Environmental Implementation Report / Functional Servicing Study for 14 Mile Creek West and the Lazy Pat Farm Property

407 West Employment Lands, 3269 Dundas Street (Lazy Pat) Oakville

North Oakville Agency Review Meeting – EIR/FSS

Figure4: Vertical Comparison of Average Water Temperatures (14W-14A: Bottom, Mid-Water, Surface)

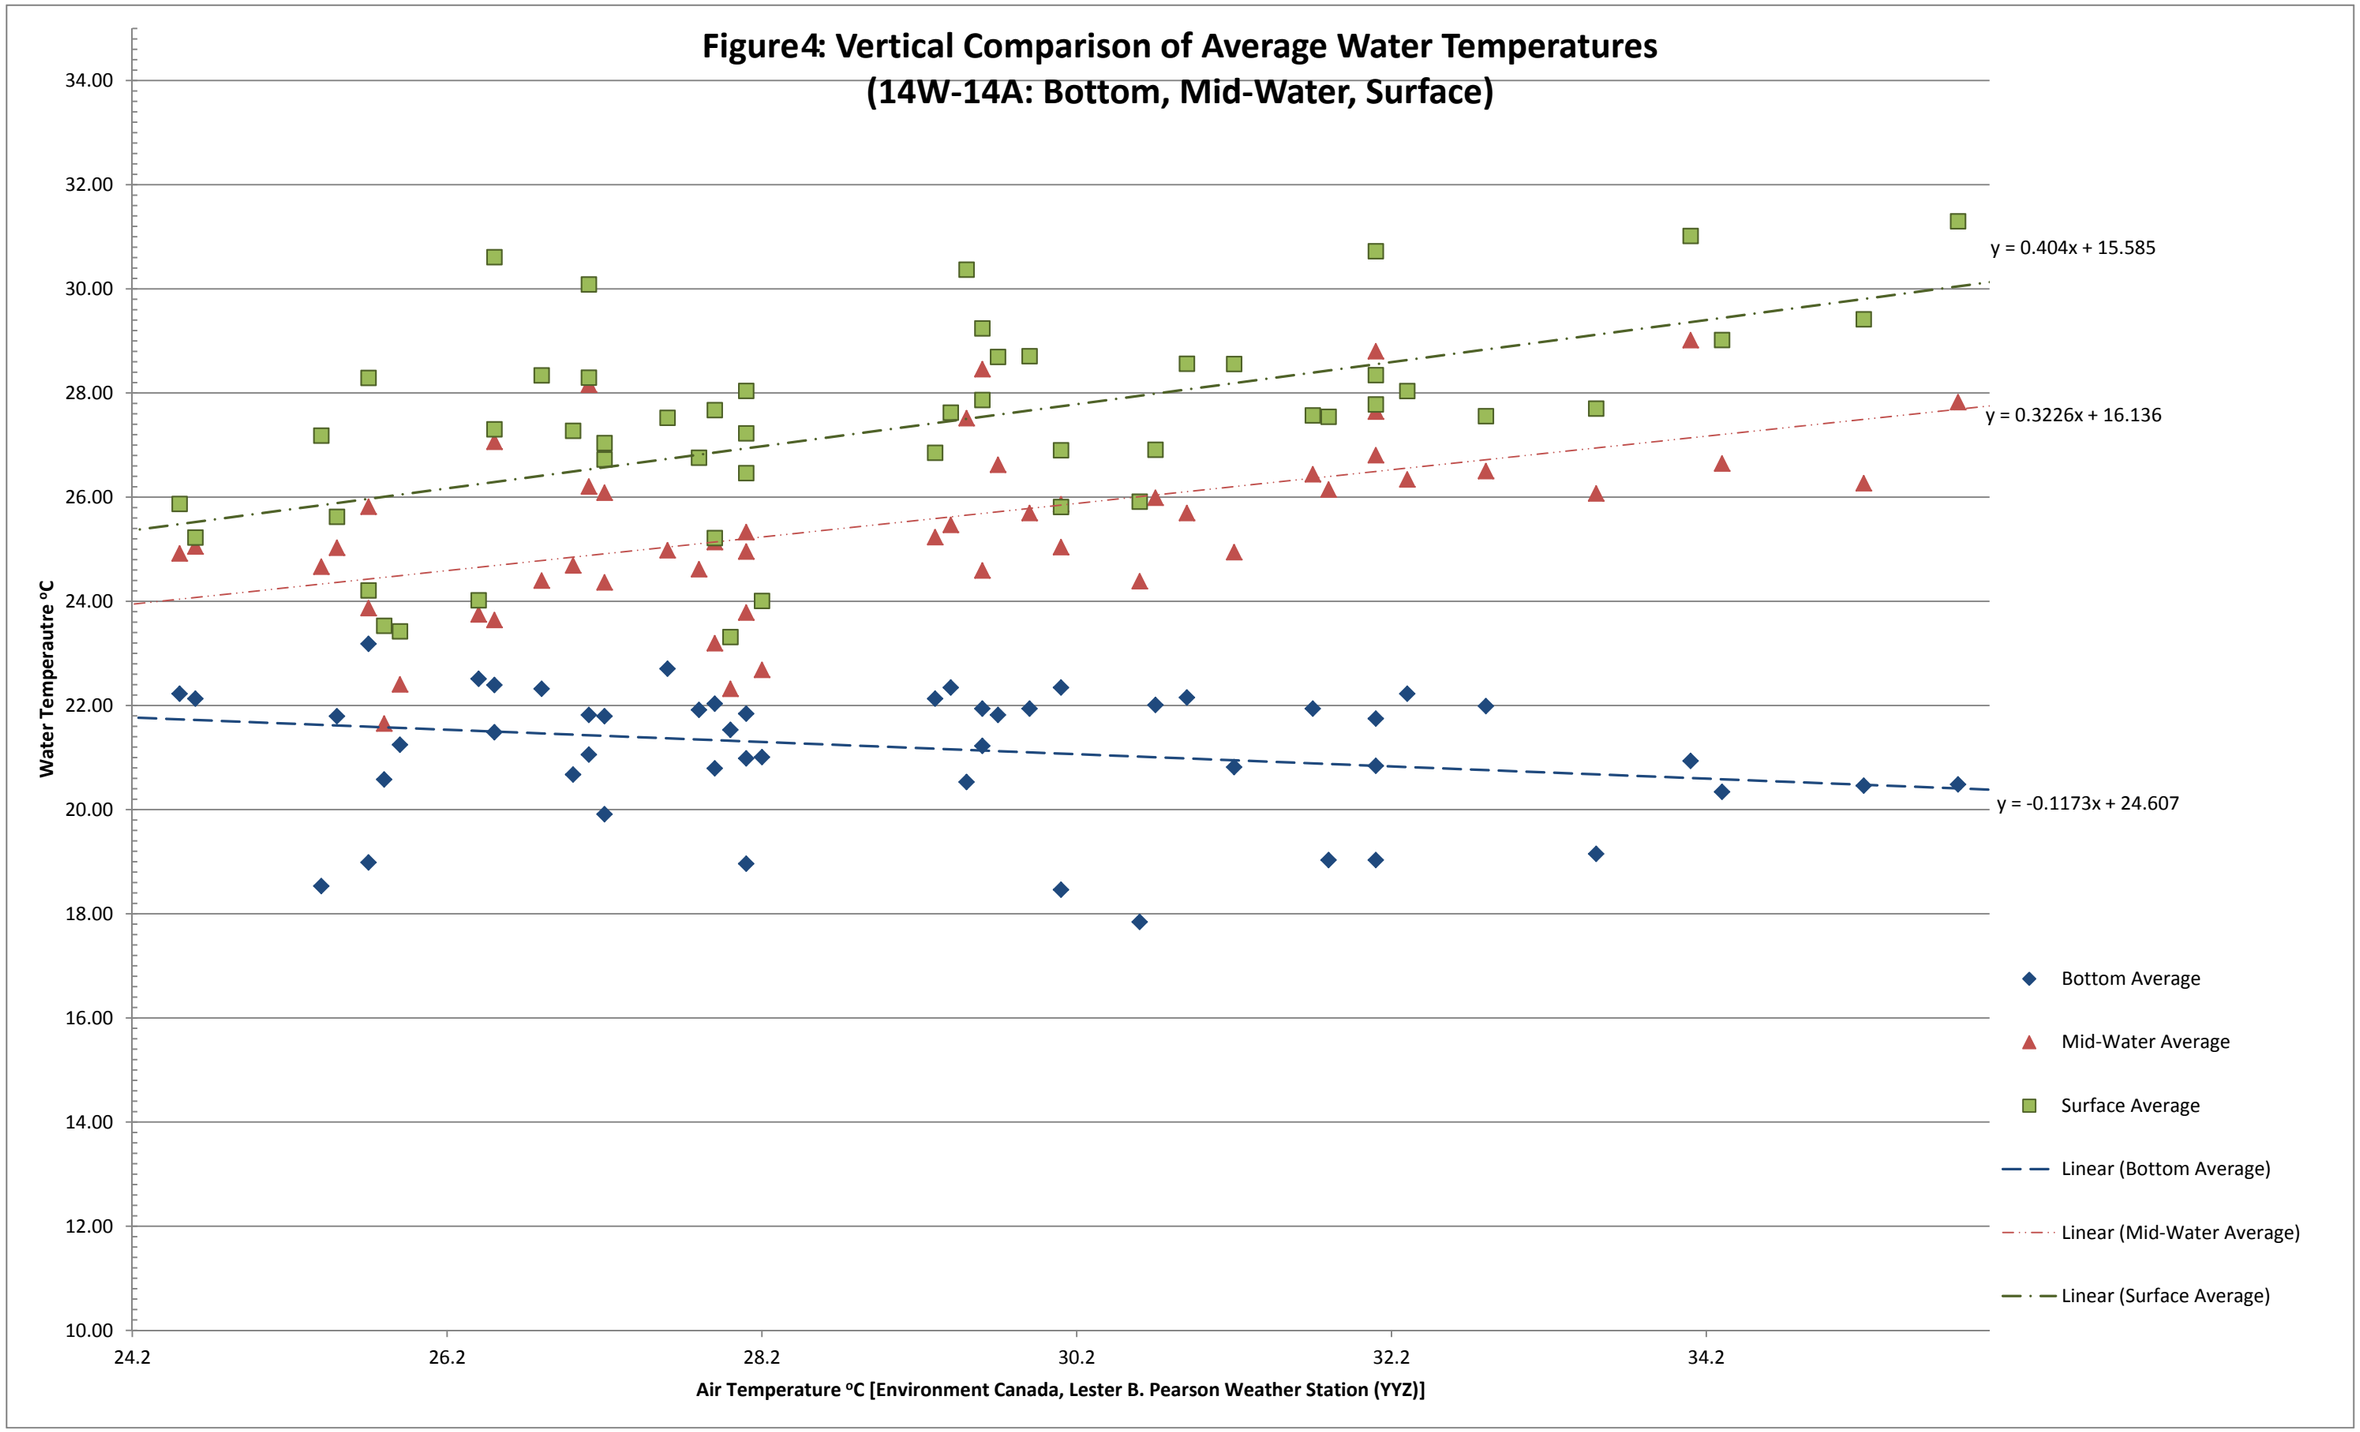
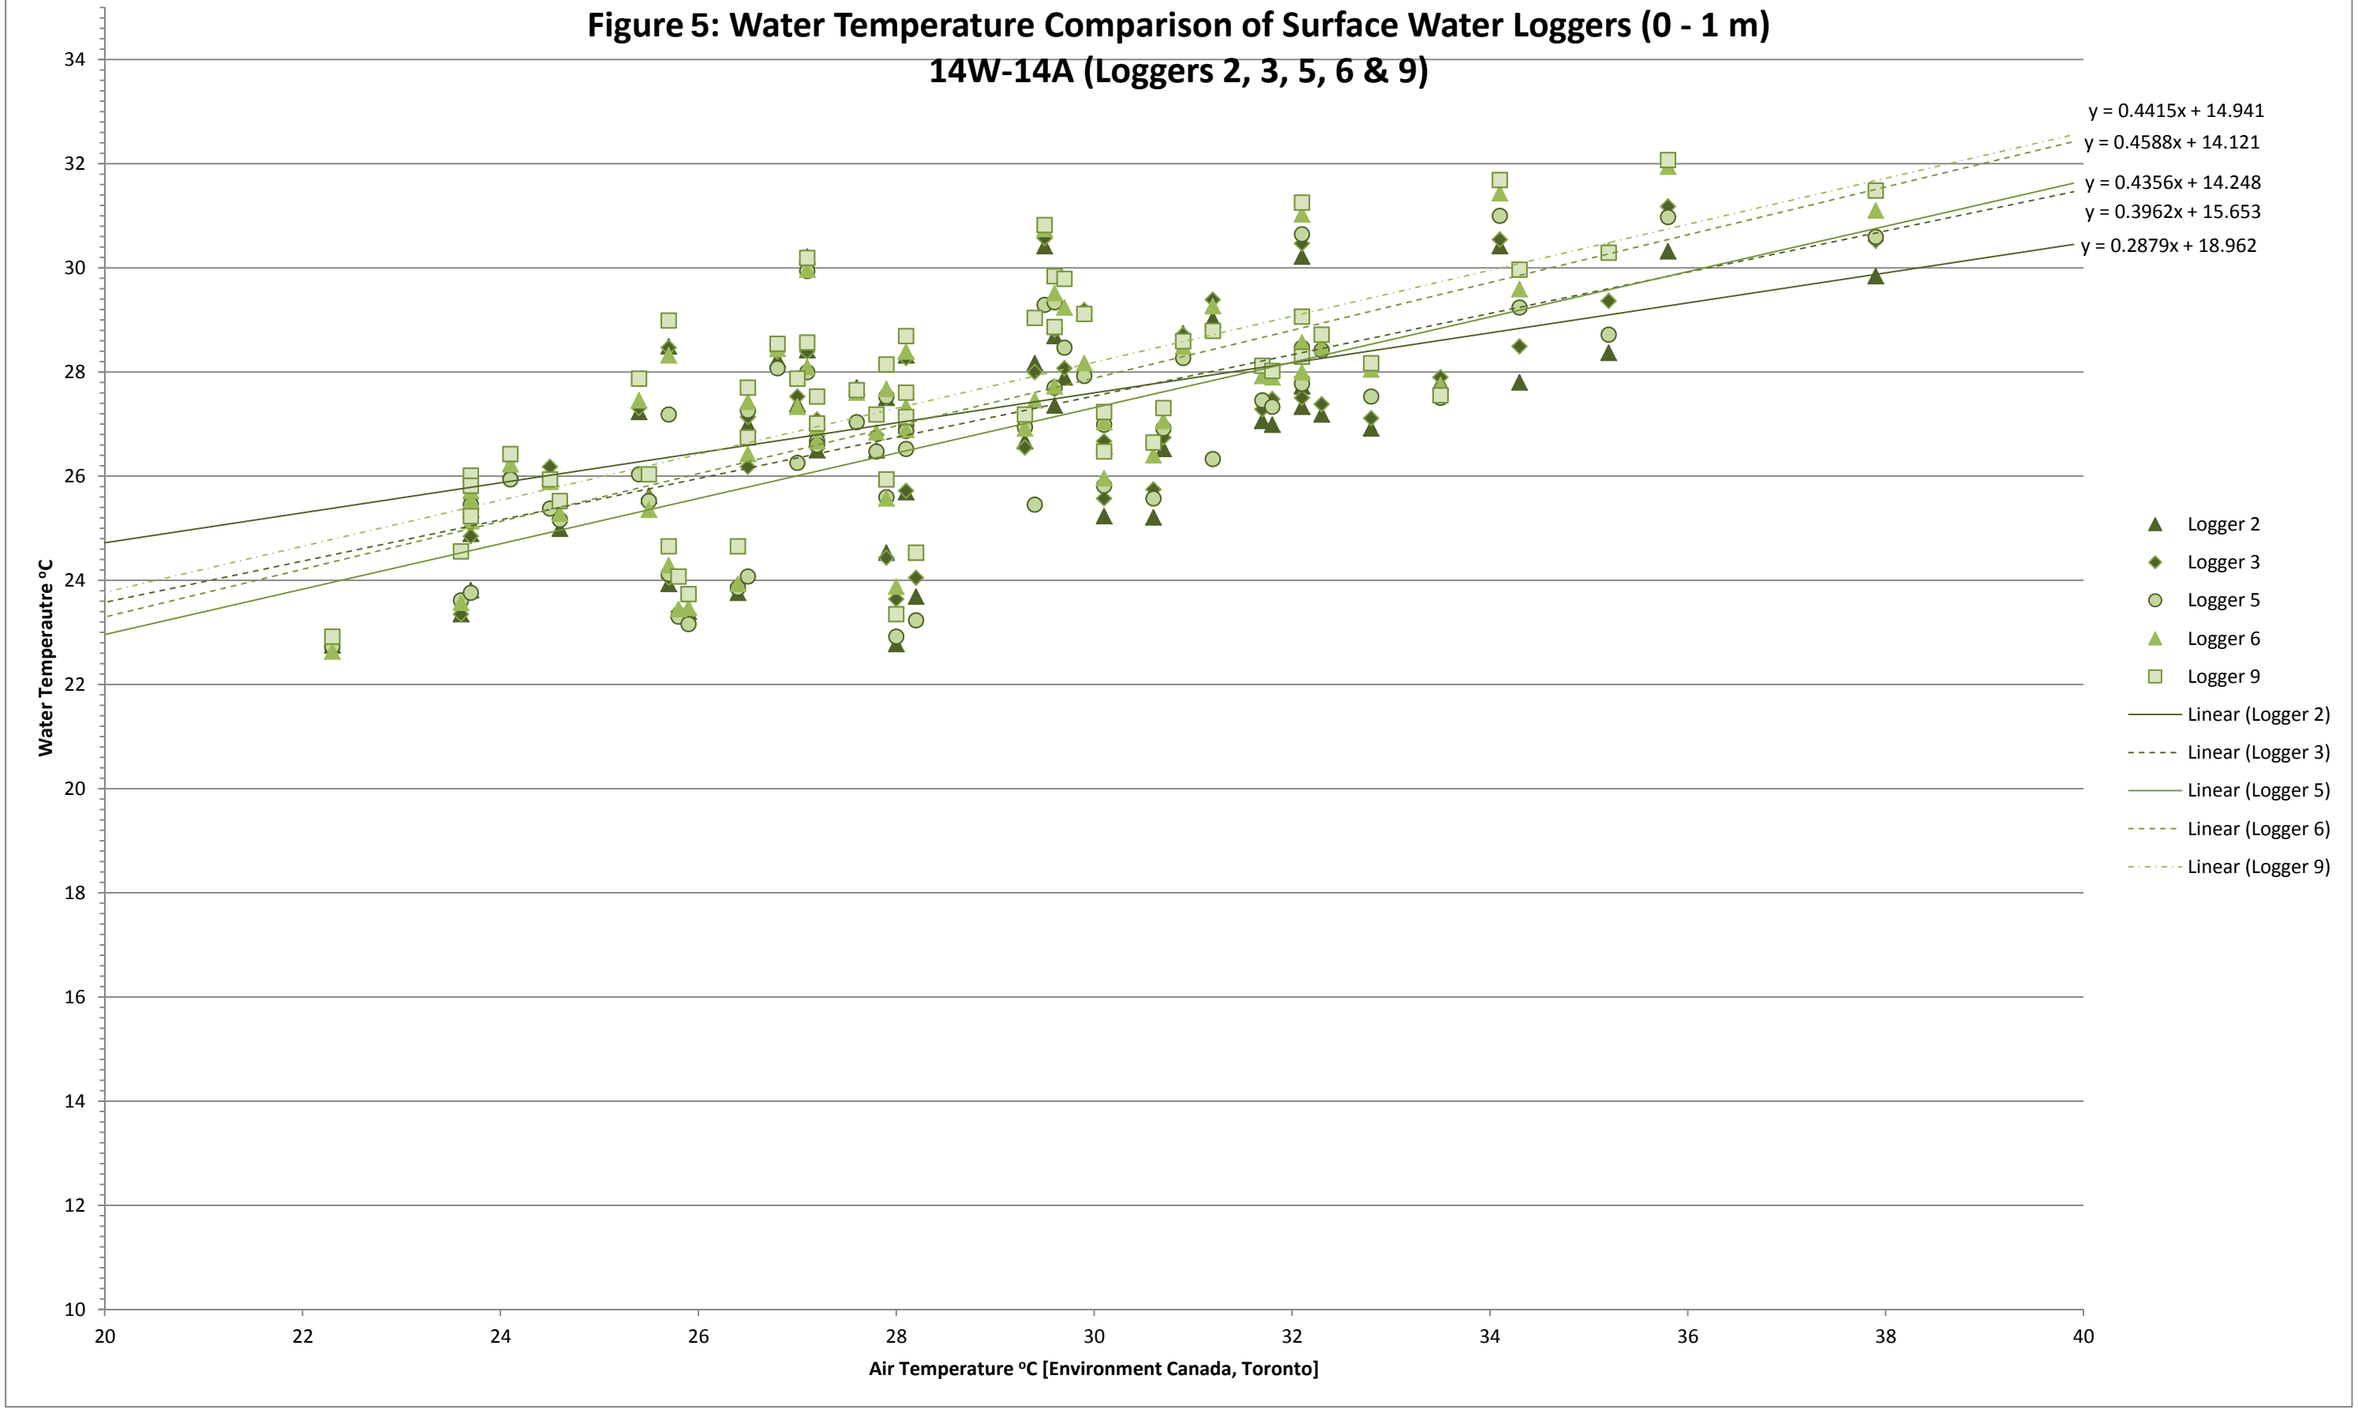
79. **Figures 4 -7, Water Temperature Comparisons at a variety of Water Depths**: Staff appreciates the effort in presenting the data in this graphical format. Staff also request that the raw numerical data be submitted to CH. Figure 7 "Water Temperature at Maximum Pond Depth: 2-3 m Depth" indicates a negative correlation between water temperature (at the deepest portion of the pond) and air temperature. It is noted that water temperature is generally observed to decrease as air temperatures increased. It is noted that on a day when air temperatures were recorded to reach 38 degrees Celsius, the water at the bottom of the pond remained at less than 21 degrees Celsius, which is cold enough to sustain Brook Trout.

79. **Figures 4 – 7 Water Temperature Comparisons at a Variety of Water Depths**: Comment no longer relevant.
